# Service Bulletin

Bulletin No.: 17-NA-357

**Subject:** Noise or Malfunction of Trim Door on Broken Quarter Upper Trim Panel, Possible Convertible Top Inoperative

4889569

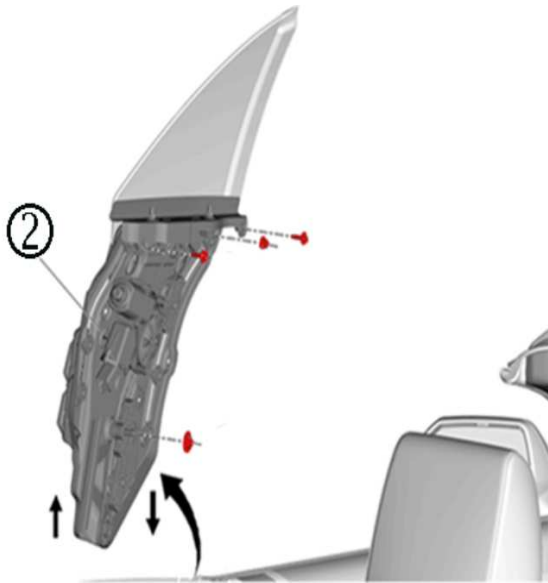
**Note:** For vehicles built **prior to February 14, 2017**, it will also be necessary to replace the window regulator in addition to the quarter upper trim panel to accommodate the added 3rd clip design.

**Important:** Under no circumstances should the 3rd clip be removed from the quarter upper trim panel.

- For vehicles built February 14, 2017 and after, replace the quarter upper trim panel (1). Refer to *Quarter Upper Trim Panel Replacement* in SI.

- For vehicles built prior to February 14, 2017, replace the quarter upper trim panel AND the quarter window regulator (2). Refer to *Quarter Window Regulator Replacement* in SI.
